TRANSMISSION / XL, XLCH-1000

The following items regarding XL/XLCH transmissions are for your attention:

ACCESS COVER OIL HOLE LOCATION

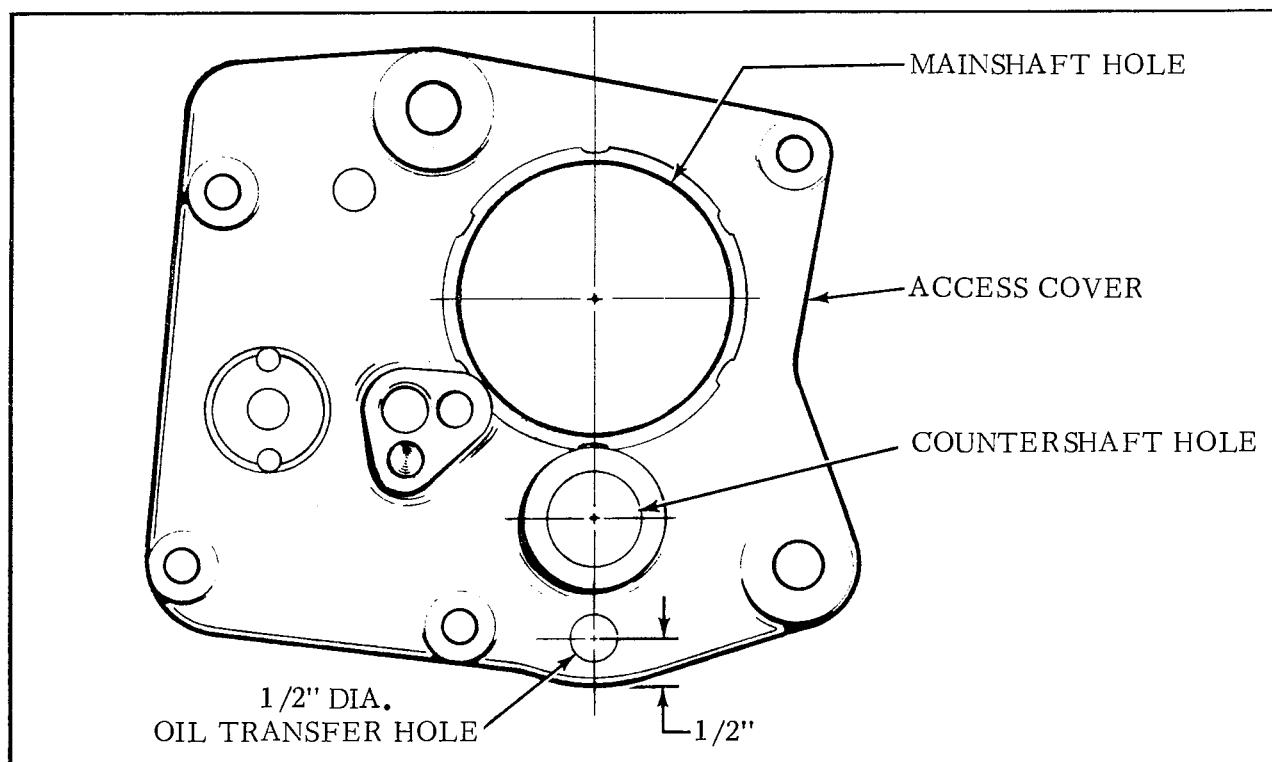
1. We have recently received several reports of Model XL/XLCH transmissions with a blocked oil transfer hole in the access cover between the chain compartment and the transmission gear box, resulting in little or no oil supply to the transmission. We recommend that the transmission drain plug be removed during setup of all 1975 XL/XLCH engines which were received before March 1, 1975, and if less than 1.5 pints of oil runs out, the access cover should be checked to see if the oil transfer hole is open. If you find that the hole is blocked, it can be opened by tapping the casting with a hammer and punch at the hole location as shown in the illustration. This should be done carefully to prevent chips from entering transmission. Loose chips should be removed from hole, or flushed out the transmission drain hole.
